A REPAIR

ON-SITE SEWAGE DISPOSAL SYSTEM HOWARD COUNTY HEALTH DEPARTMENT BUREAU OF ENVIRONMENTAL HEALTH

ADDRESS: 11920 Frederick Road PROPERTY OWNER: _____

1050 Gallon Septic Tank Double Compartment

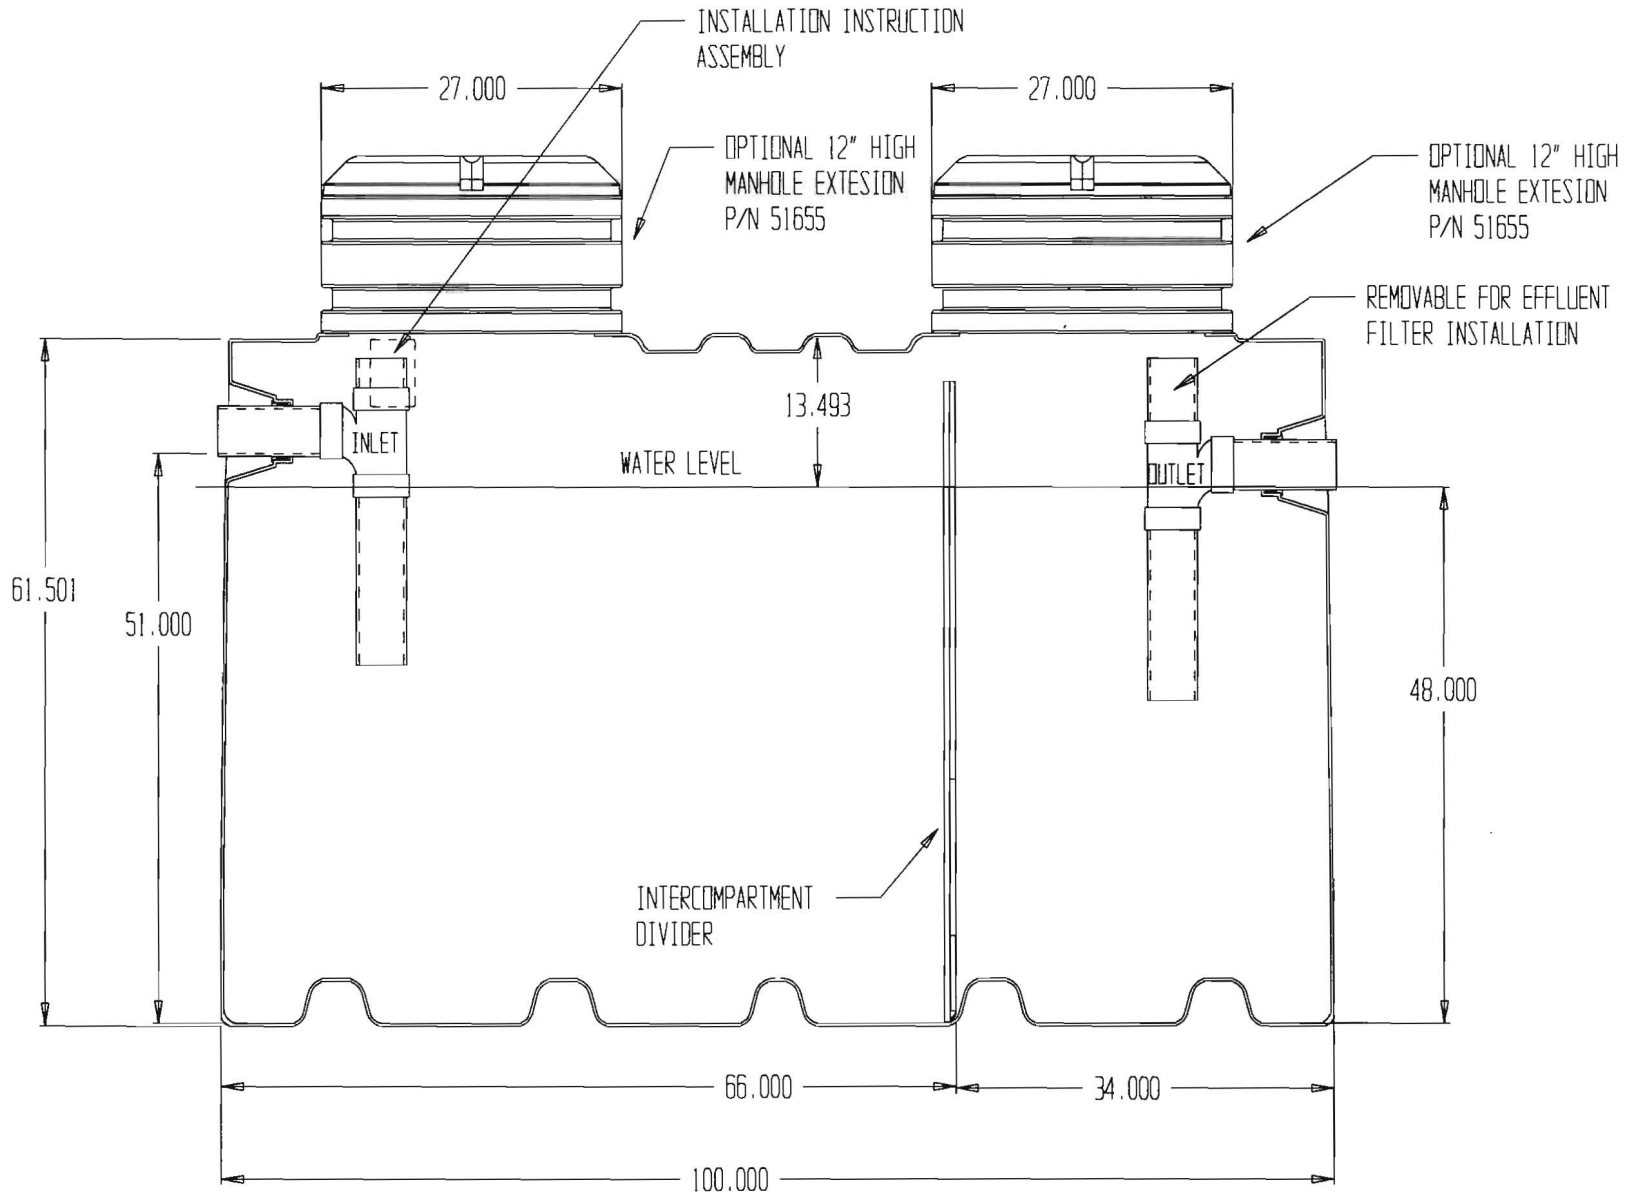
INSTALLATION 11/1/06 Snyder AMSTK 1050 gallon 2-compartment plastic tank to be installed because of truck access issues. Tank to be less than 3' below grade and set on a bed of sand or fine gravel. (BB)

11/3/06 Tank set per installation on fine sand roughly 6". Told Contractor to backfill carefully so tank doesn't roll. (156)

Approved. (129)
